# Access Compliance Report

## Public Rights-of-Way

Intersection ID: 14383	Main Street: CLEVELAND_AV	Cross Street: E_TREMONT_AV	Location: S
ADA ID: 469D4D6887E2	Ramp Type: PerpDiag	Initial Pass/Fail: Fail	Overall Compliance: No
		Severity Score: 12.5

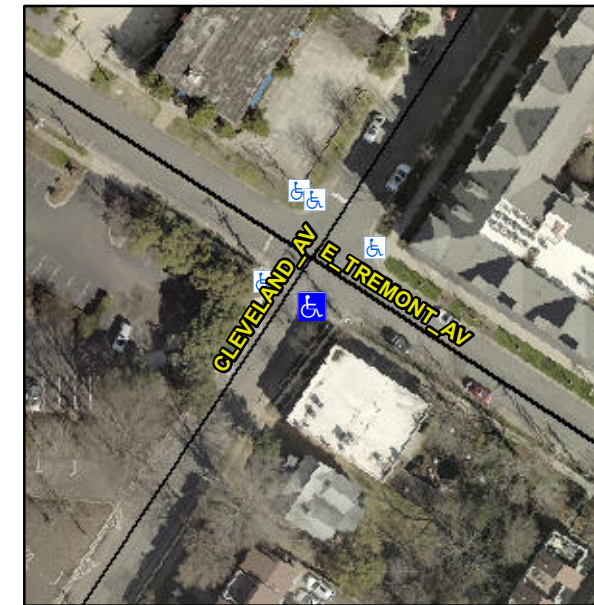
**Not Found, R304.5.3**

Compliance	Description	Data	Compliance	Description	Data
N/A	Ramp Length (in)	50.0	Yes	Ramp Slope (%)	6.7
Yes	Ramp Width (in)	48.0	No	Ramp XSlope (%)	5.2
N/A	Flare Type LT	N/A	N/A	Flare Type RT	N/A
N/A	Flare Slope LT (%)	N/A	N/A	Flare Slope RT (%)	N/A
N/A	Flare Traversable LT?	N/A	N/A	Flare Traversable RT?	N/A
N/A	Landing Length (in)	N/A	N/A	DWS Provided?	N/A
N/A	Landing Width (in)	N/A	N/A	DWS Contrast?	N/A
N/A	Landing Slope (%)	N/A	N/A	DWS Length (in)	N/A
N/A	Landing X Slope (%)	N/A	N/A	DWS Full Width?	N/A
N/A	Landing Curb? (Y/N)	N/A	N/A	DWS Offset (in)	N/A
N/A	Shared Landing?	N/A			
N/A	Gutter Ponding?	N/A	N/A	Gutter Slope (%)	N/A
N/A	Gutter Lip Ht (in)	N/A	N/A	Gutter X Slope (%)	N/A
N/A	Painted X Walk1?	No	N/A	Painted X Walk2?	No
	X Walk 1 Direction	To NE		X Walk 2 Direction	To NW
N/A	X Walk 1 Width (in)	N/A	N/A	X Walk 2 Width (in)	N/A
	X Walk 1 Slope (%)	1.9		X Walk 2 Slope (%)	6.8
	X Walk 1 X Slope (%)	3.4		X Walk 2 X Slope (%)	0.9

**Remove & Replace Curb Ramp With Two New Directional Ramps or Equivalent.**
